June 26, 2006

**ADDENDUM NO. 2  
TO  
THE PLANS AND SPECIFICATIONS  
FOR THE  
SOUTH BAY WATER RECYCLING PROGRAM  
SJ-14 SJ/SC PUMP STATIONS 5 AND 8/11 RELIABILITY PROJECT**

# SECTION

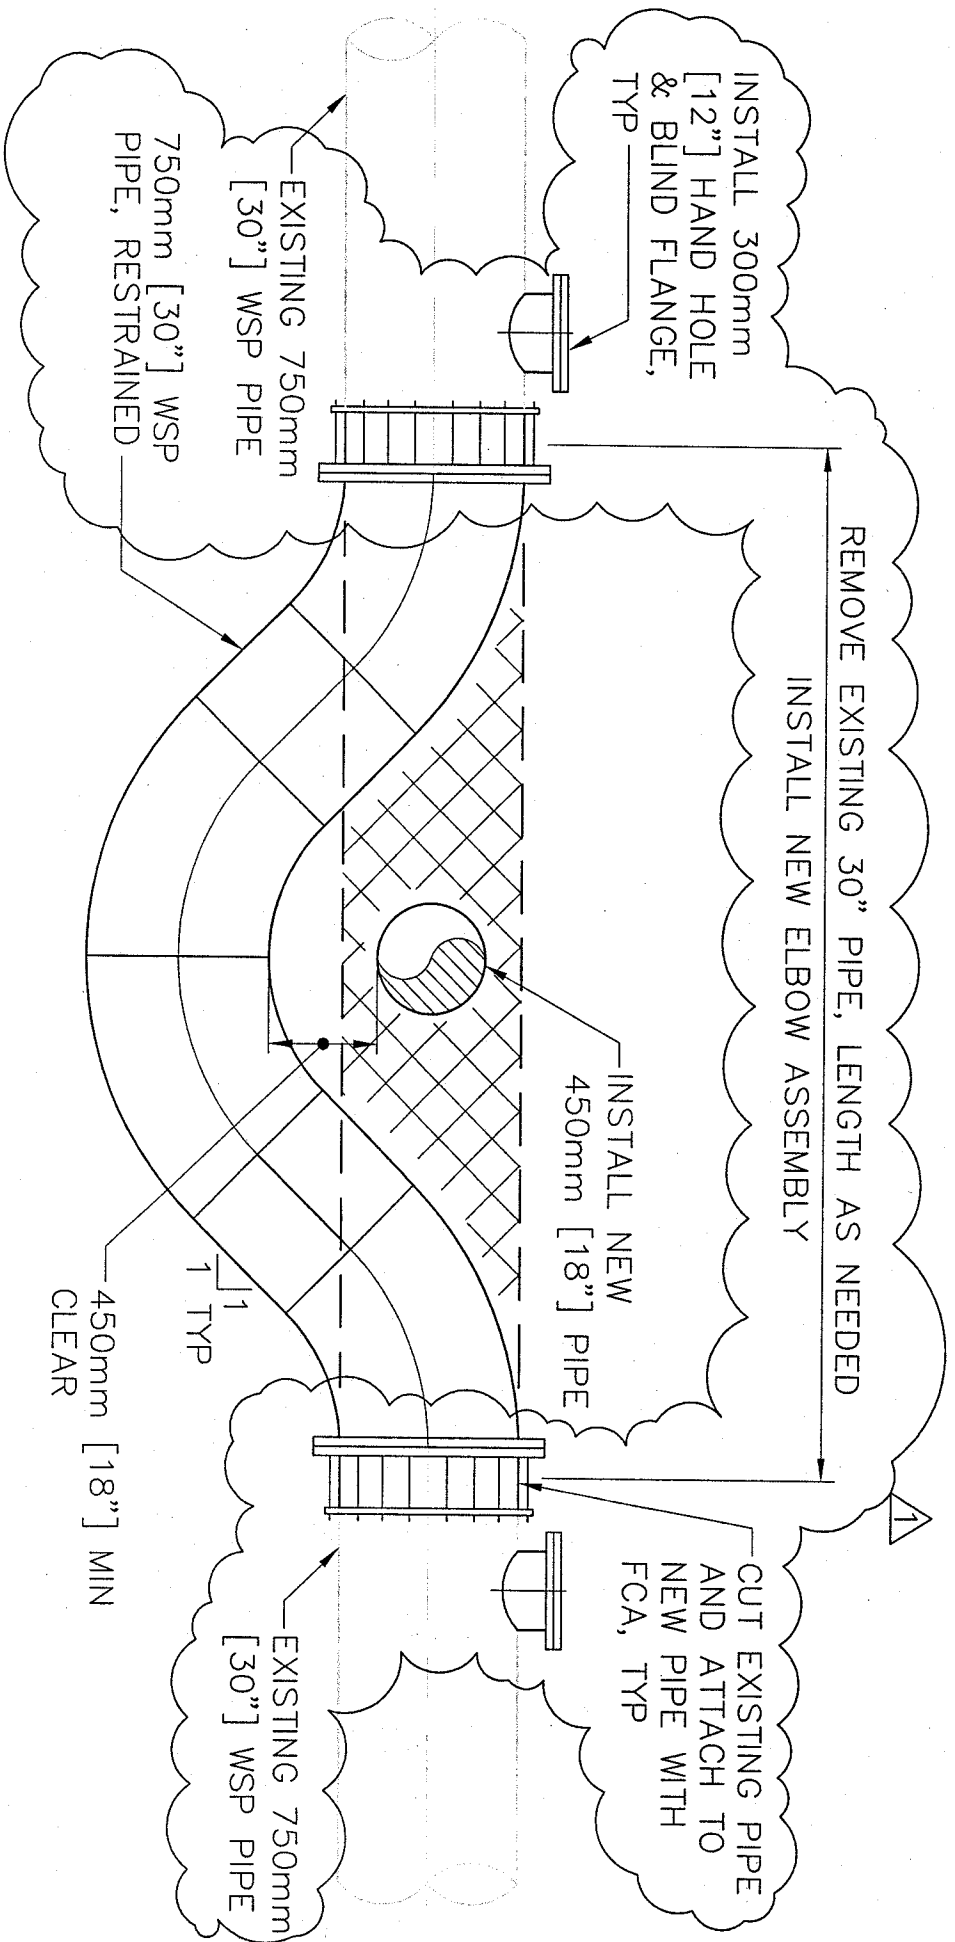
### 15. DWG NO. C-1, SECTION A.

Delete SECTION A and replace with attached SECTION A.
